WEM Procedure: Frequency Co- Optimised Essential System Services Accreditation

Prepared by: AEMO

Version: 2.01-1

Version	Effective Date	Summary of Changes
0.1	08 September 2021	Draft WEM Procedure for Consultation
1.0	01 October 2021	New WEM Procedure.
2.0	xx	Updated WEM Procedure

Figure E[3] Example of measured response against theoretical Response Profiles.

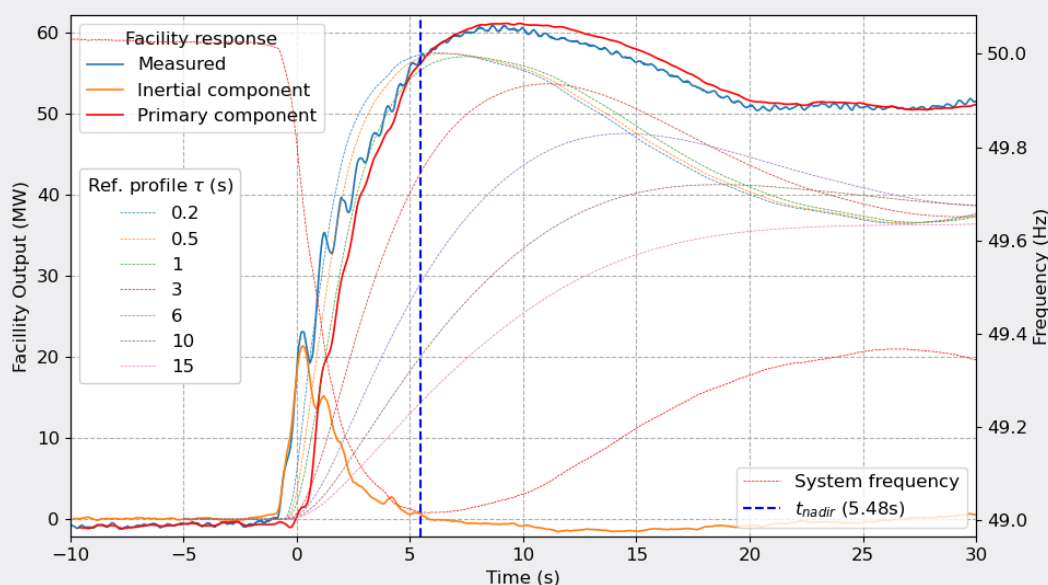
The Reference Profiles in Figure E[23] are based on the acceptable range of Facility Speed Factors, as published by AEMO in accordance with paragraph 6.2.116.2.106.2.106.2.11, band acceptable range at that time (i.e. [0.2, 0.5, 1, 3, 6, 10, 15] (s)), where a faster response has a lower Facility Speed Factor. Figure E[34] shows the integrated response (in MWs) of the same Facility as an integrated response (in MWs) compared to integrated Reference Profiles, tThis shows the Facility response exceeding the that of associated with the Reference Speed Factor of two three seconds at the frequency nadir time. Reference Speed Factor.

Figure E[5] RoCoF Ride-Through Cost Recovery Limit

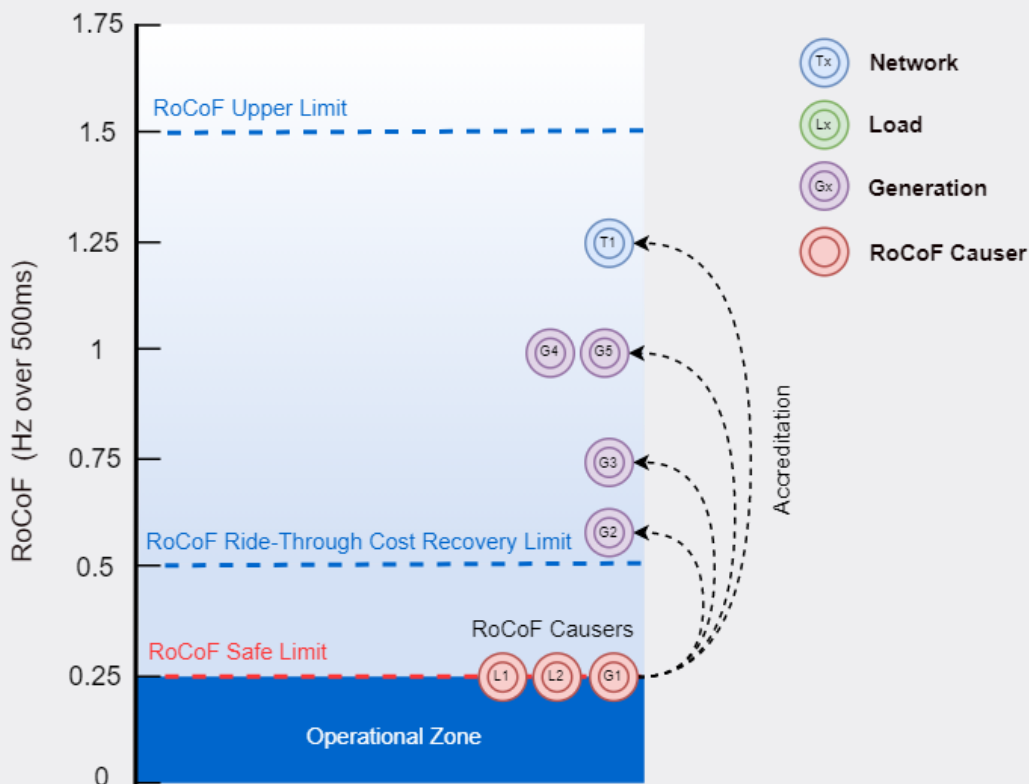
Figure E[4] provides a simplified example of Facilities ~~which that~~ may ~~be~~ accredited for a their RoCoF Ride-Through Capability ~~to a value~~ greater than the RoCoF Ride-Through Cost Recovery Limit. In this example, the RoCoF Causers are deemed by AEMO to have a RoCoF Ride-Through Capability at the RoCoF Safe Limit. In this example, those Facilities would be RoCoF Causers for the purposes of RoCoF Control Service cost recovery.
